## Appendix D

### Responses to Data Requests

In the Matter of the Application of Snowshoe BESS, LLC for a Site Permit for the up to 150 MW Snowshoe Energy Storage Project in Olmsted County, Minnesota

PUC Docket No. IP-7138/ESS-24-270

Soils - Hydric Classification - Response to DR-10

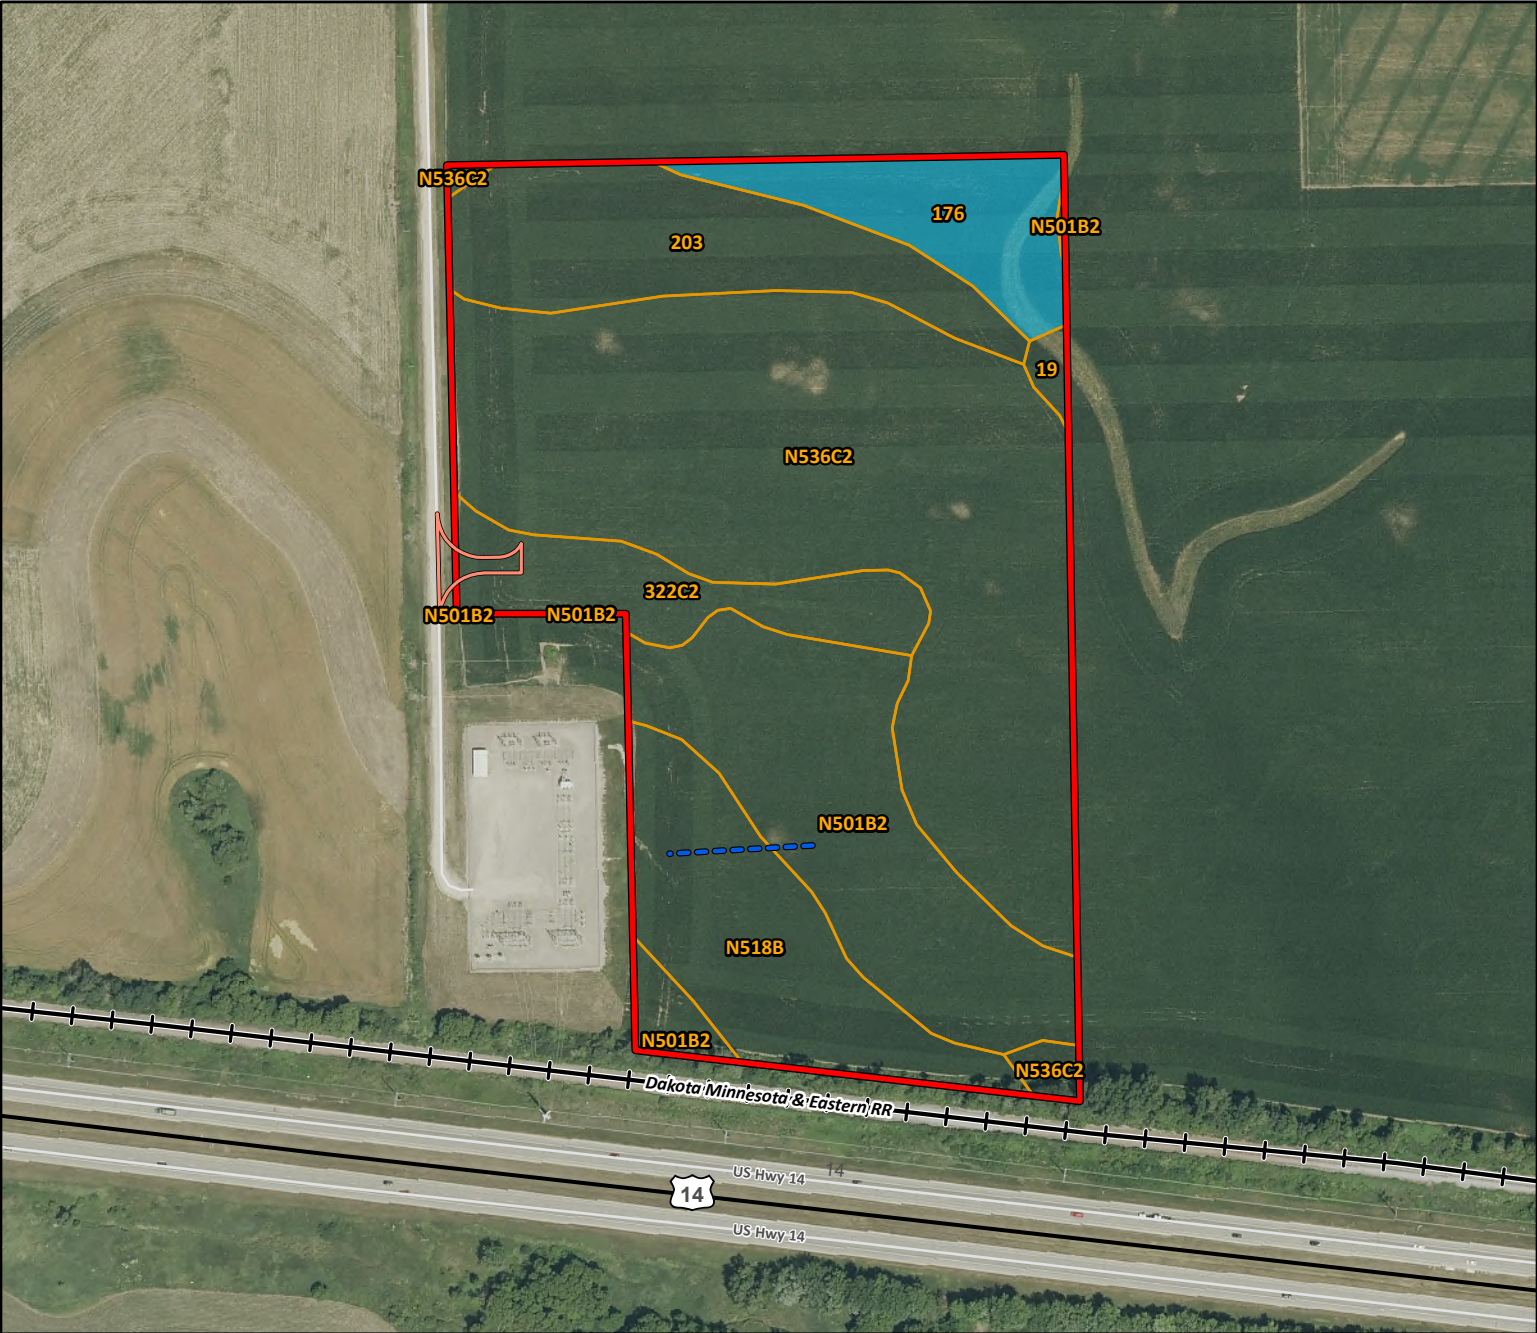
The soils identified at the Snowshoe site in the application (Table 5.5-4 and Figure 7) differ somewhat from those identified in EERA's site review at the NRCS soil survey

In particular, the NRCS map shows Tama Silt Loam (N536C2) in the area shown in application materials as Port Byron Silt Loam (285C) and Downs Silt Loam (N501B2) in the area shown in application material as Mt. Carrol Silt Loam ((401B).

Please review the source material and clarify the soil types. If applicable, please provide updates to Table 5.5-3 and Figure 7.

Snowshoe BESS, LLC created Figure 7 using soil data from the USDA Web Soil Survey (WSS). The USDA Natural Resources Conservation Service (NRCS) updated their soil database in October 2024 after Figure 7 was prepared and therefore the figure did not reflect the most recent updates to the database.

As requested, Snowshoe BESS, LLC revised Figure 7 and Table 5.5-4: Project Area Soils to reflect these recent changes made to the Web Soil Survey.
